UNITED STATES PATENT AND TRADEMARK OFFICE

Office Action Summary

10/729,231

DETAILED ACTION

Wang (6,712,106) disclose, Air and gravitational force from the top of the dome section curve the debris substantially, 90°

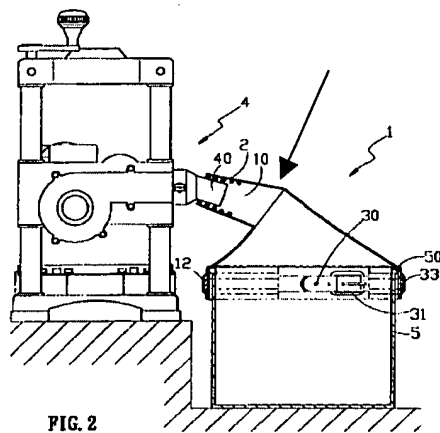
With regard to claim 15 and 16, as best as can be understood, Wang discloses a part spherical shaped section (10; fig. 2) that curves the path of the debris as it passes through the part spherical section.

As to the 90 degrees (clm. 16) Examiner notes that the spherical section (10) curves the path of the debris and that some of the debris will follow the spherical section (10) to a highest most point and fall by air and gravity force downward, i.e., at a 90 degrees (fig. 2).
